October 13, 2008

**RE: North Country Environmental Services, Inc.
Landfill Facility – Bethlehem, New Hampshire
Response to September 10, 2008 NHDES Comment letter**

**RE: Liner Leakage Analysis
North Country Environmental Services
Bethlehem, New Hampshire
CMA #656.03 - A**

Figure 1 - Liner System Schematic

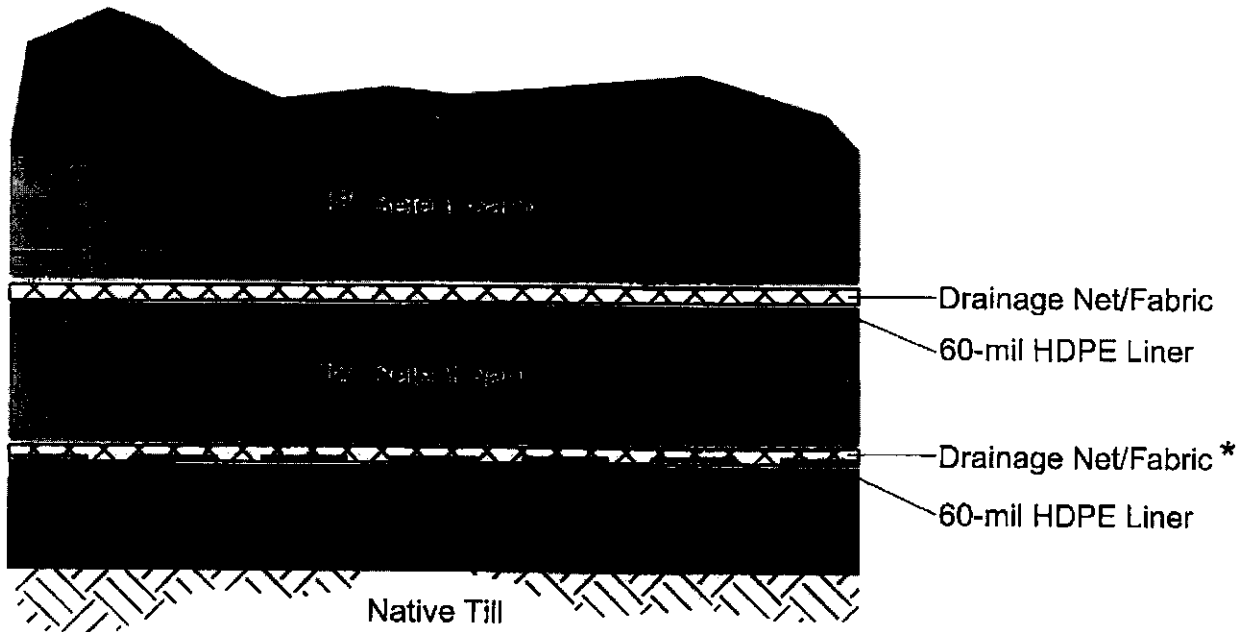
A typical lining system schematic for the NCES landfill is provided on Figure 1. The primary liner and leachate collection system consists of 18 inches of drainage sand, underlain by a drainage geocomposite (newer phases) or a drainage net and fabric (older phases), which in turn is underlain by a 60-mil high density polyethylene geomembrane liner. The secondary collection system is essentially a duplicate of the primary system with the same components and drainage capacity except for the flat, base areas of Stage I Phase II and III which do not incorporate drainage net/composite in the secondary collection system.

Figure 2 - Groundwater Flow Directions

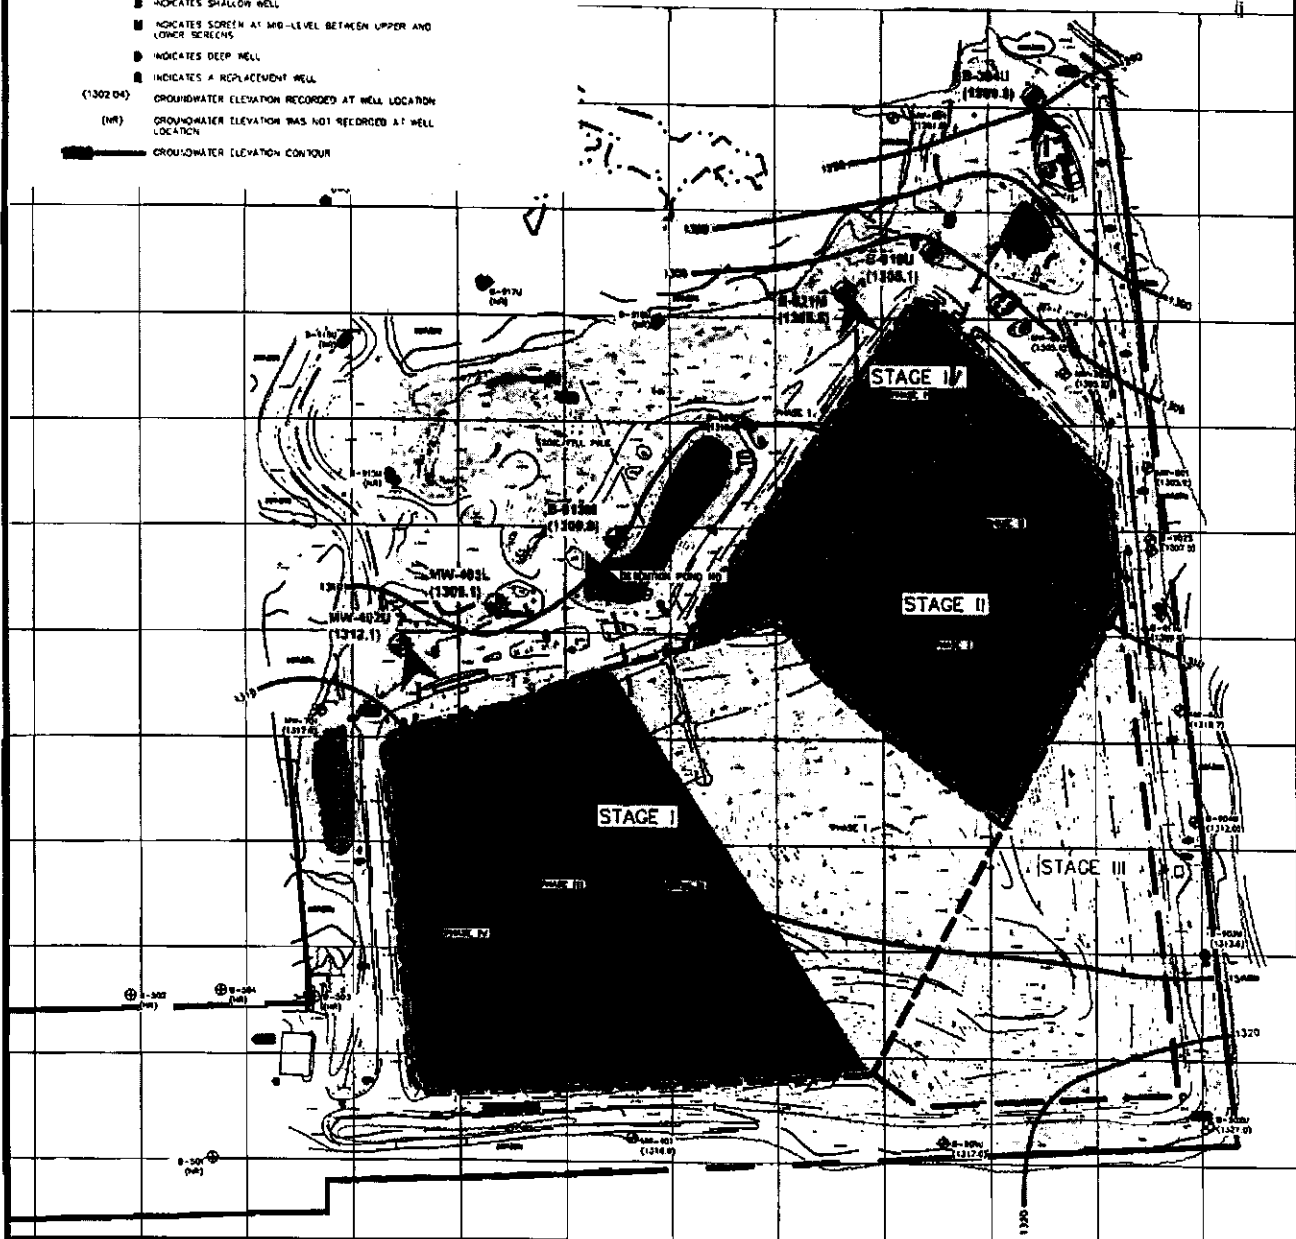
We conducted the leakage analyses on those landfill phases located upgradient of the impacted wells. As shown on Figure 2, Stage I Phases 2, 3, and 4 are located upgradient of wells MW-402U, MW-403L, and B-913M. Stage IV Phase I and Stage II Phases I and II are located upgradient of wells B-921M, B-919U, and B-304-U.

Figure 3 - Secondary Leachate Collection Systems

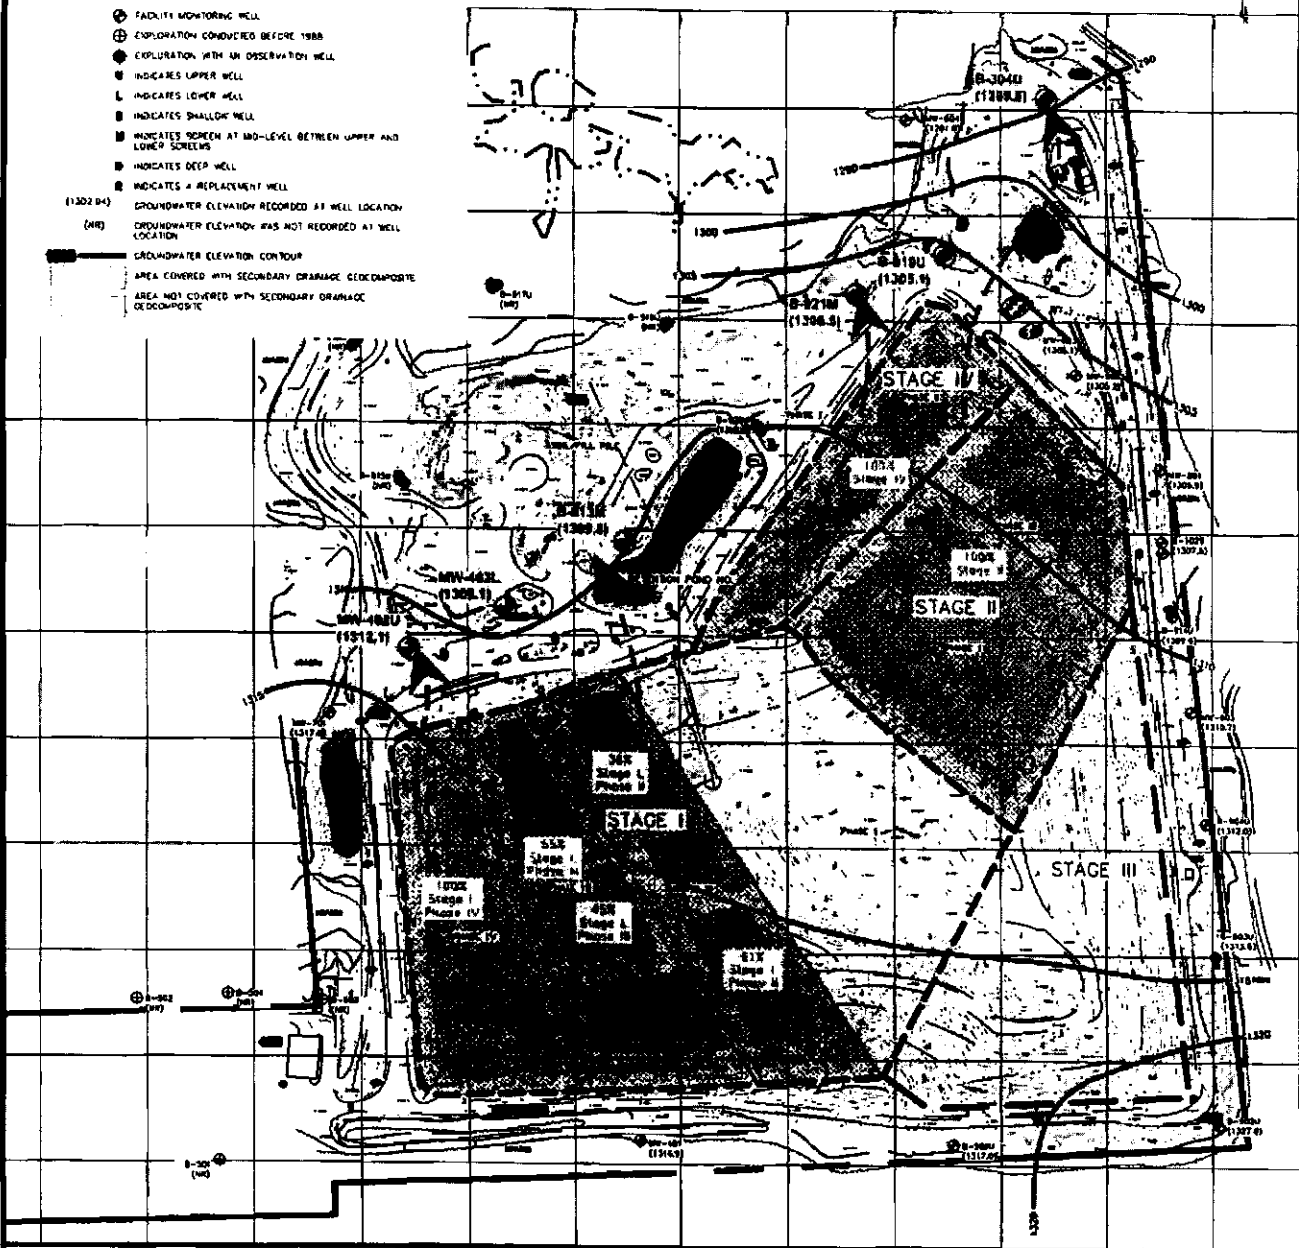
- Calculate the average head on the secondary liner using actual secondary flow data and the procedure described above for the primary liner, and account for the lack of drainage net on the flat base areas of Stage I Phases II and III. In these areas secondary flow is drained by drainage sand alone. The drainage sand is not as transmissive as the drainage net, resulting in higher heads on the liner than in areas with the drainage net. The landfill areas without drainage net are shown on Figure 3.

Dichlorodifluoromethane in Select Wells
 NCES Landfill
 Bethlehem, New Hampshire

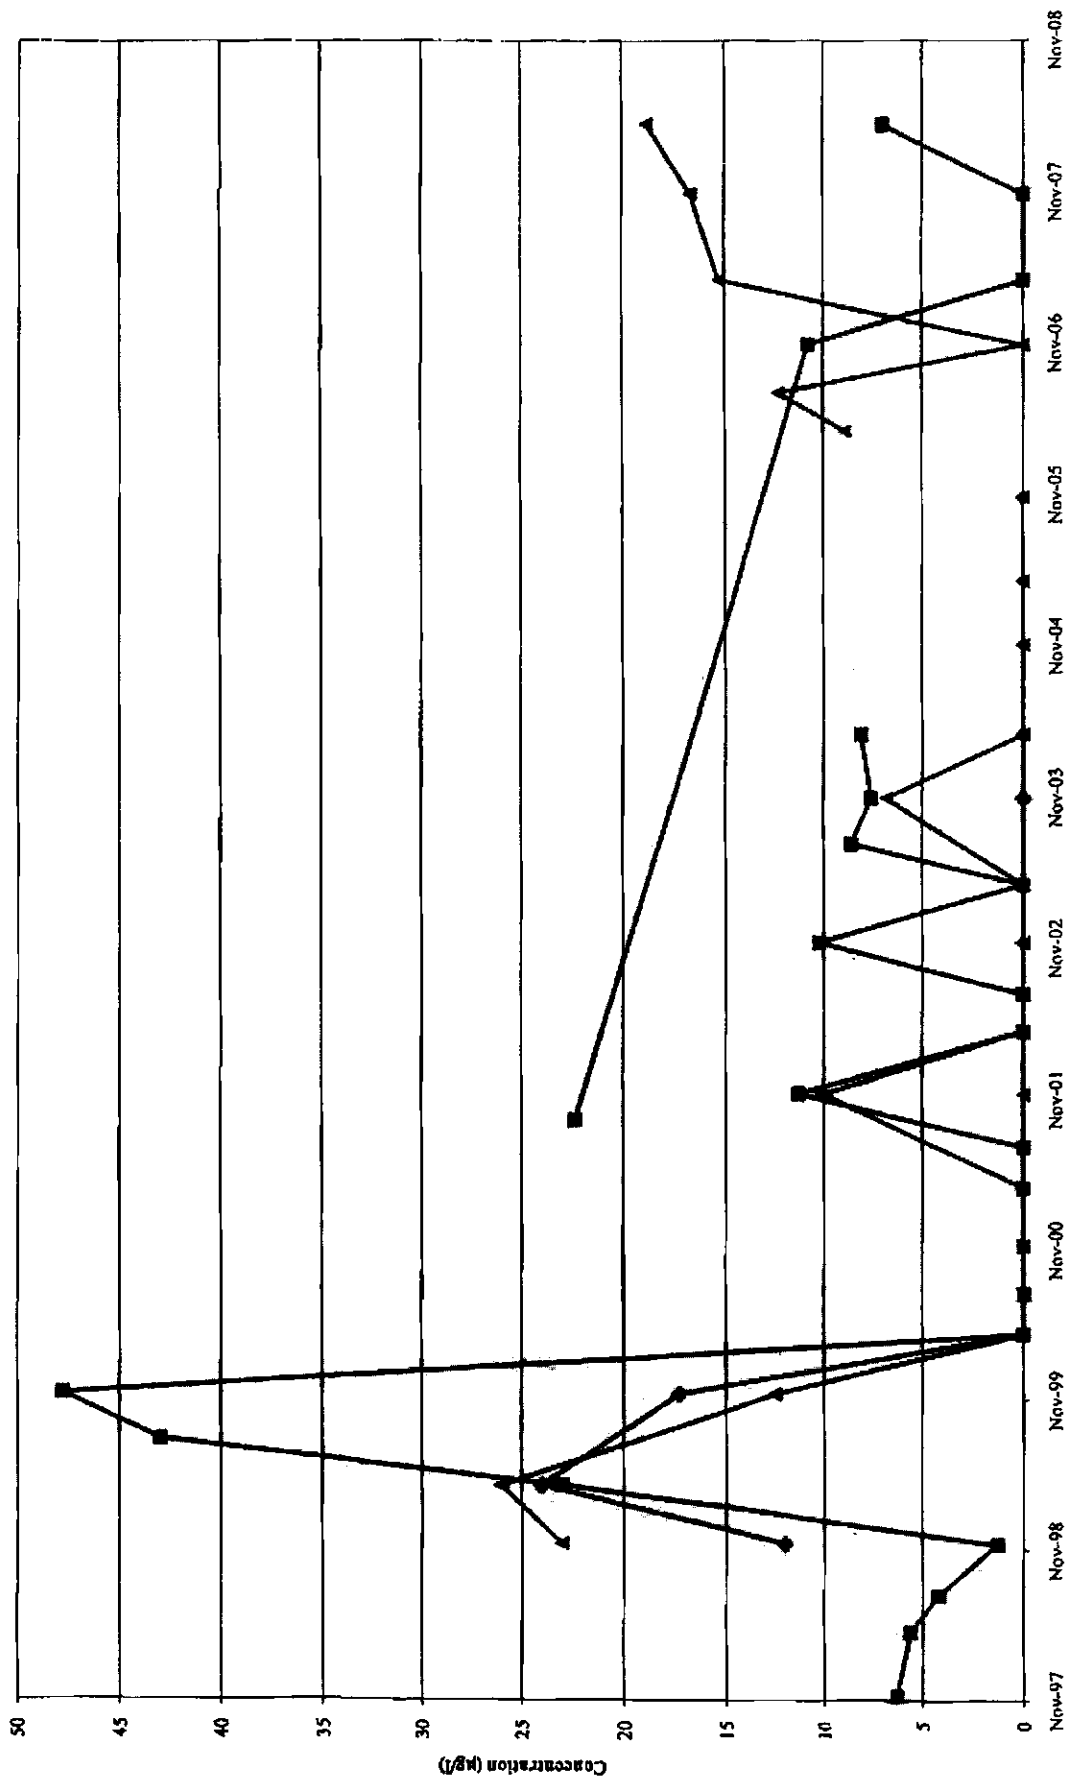
The VOC dichlorodifluoromethane has been detected at concentrations above background in wells B-919U and B-921M. The data from the April 2008 groundwater sampling round indicate that the concentration of this compound is increasing in well B-921M.

In addition, bromide continues to be detected in B-921U above background concentrations. The April 2008 results detected bromide at 1.7 mg/l. SHA's September 28, 2007 Annual Report indicates that the elevated concentrations of bromide in this monitoring well appear to be related to the

The history of dichlorodifluoromethane (DCDFM) detections in wells B-919U and B-921M is summarized on the attached figure (Exhibit B), which provides a graphical summary of the available VOC sampling results for these wells. These wells are both screened within the stratified-drift unit as observed in this area of the site. As noted in SHA's 2008 Annual Report, DCDFM was also historically detected in former stratified-drift monitoring wells located in the area of what is now the Stage IV / Phase I Landfill, which is upgradient from the area of wells B-919U and B-921M, with respect to groundwater flow. The attached figure also includes the available history of DCDFM concentrations detected in historical groundwater samples collected from three of these latter wells (B-101, MW-804, and MW-805), which were decommissioned, with NHDES approval, prior to construction of the Stage IV / Phase I Landfill.

As indicated on the attached figure, DCDFM concentrations have generally ranged from non-detect to just under about 20 micrograms per liter (ug/l) in the recent samples from wells B-919U and B-921M, which is less than the highest concentrations historically detected in wells B-101, MW-804, and MW-805. DCDFM concentrations reported for these latter three wells had decreased to non-detectable levels for at least several rounds (wells MW-804 and MW-805) or were suggestive of a generally-decreasing temporal trend (B-101) prior to well decommissioning. Based on these conditions, we believe that the presence of DCDFM in groundwater in the area of wells B-919U and B-921M is likely related to the historical occurrence (former unlined landfill) of this compound in groundwater in the areas upgradient from these wells, and thus a result of continued northerly migration with groundwater flow. As observed previously in the historical data for wells MW-804 and MW-805, we expect that future groundwater monitoring results for wells B-919U and B-921M will support a general trend of decreasing DCDFM concentrations in groundwater at these latter locations.
